CITY OF GARDEN CITY

STAFF REPORT

File Number: DSRFY2024 - 0013

Location: 575 E. 42nd Street

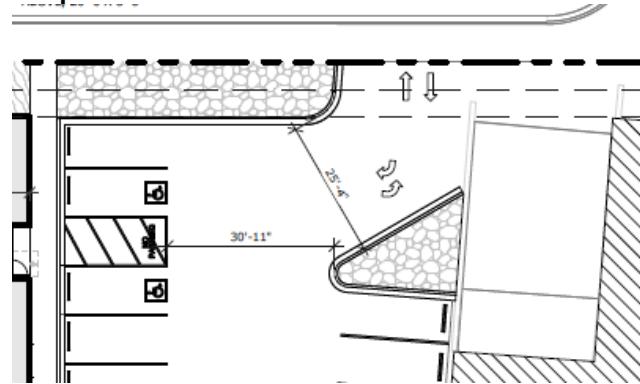
Parking Lot Locations: All parking lots should be located to the side and rear of the building fronting on the street. **Compliant**

Driveway Lanes: Driveway lanes crossing a public sidewalk should be no wider than twenty feet (20') and the minimum of feet between driveway intersections with the public street as set forth by the transportation authority. Driveway lanes crossing a public sidewalk intersection should be clearly distinguished with special pavement or coloring. **According to section 8-4D-3 of the code, when parking at a 90-degree angle, the driveway shall be 22'. Unless additional requirements from the North Ada County Fire Department are specified, the drive isle will need to be 20' where the public sidewalks cross the driveways, then the drives can widen.**

The driveway on the western portion of the property is 20 feet wide and does not contain parking stalls.

The driveway on the eastern portion of the property has a specific configuration. In accordance with the recommendations made at the Design Consultation on August 19, 2024, the existing driveway was retained and will be used as shared access with Fisher's existing curb

cut. The driveway is now 30 feet wide inside of the property and narrows to 25 feet at the entrance/exit. The width of the driveway onto the lot, together with the loading area in the adjacent building, is not specified in the plans.

Pedestrian Pathways: Partially provided. Parking at the rear boundary of the site is not connected by pedestrian paths to the entrance to the building.

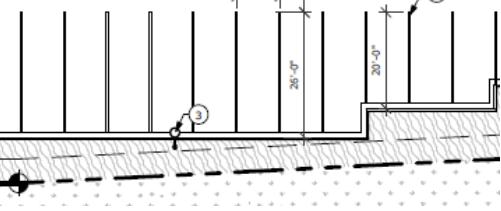
<p>Part of the required 10-foot perimeter landscape was partially reduced at the southern boundary of the property.</p>  <p>A screen consisting of vegetation shall be at least six feet (6') wide and six feet (6') in height at maturity; Compliant</p> <p>At least one tree shall be planted for every fifteen (15) linear feet of perimeter length (or as appropriate to the selected species) to quickly establish continuous canopy coverage. Compliant</p> <p>The parking lot and driveway on the east side of the existing building adjacent to the Greenbelt. The plans do not show a perimeter landscape along the eastern boundary. May not be compliant</p>
<u>8-4I-6 Parking Lot Landscaping Provisions</u>	DRC/PZ/CC	Not Compliant	<p>Based on Resubmittals dated 08/28/2024</p> <p><u>Proposed building:</u></p> <p>The provisions of this section shall apply to all new or substantially altered parking lots of five (5) spaces or more.</p> <p>Internal shade trees shall be provided at a minimum ratio of one tree planted for every five (5) parking spaces supplied. Not provided.</p> <p>Include landscaped islands with at least one tree at the beginning and end of each parking row and to break up longer rows. Provided.</p> <p><u>Existing building:</u></p> <p>There appear to be no trees in the existing parking lot.</p>
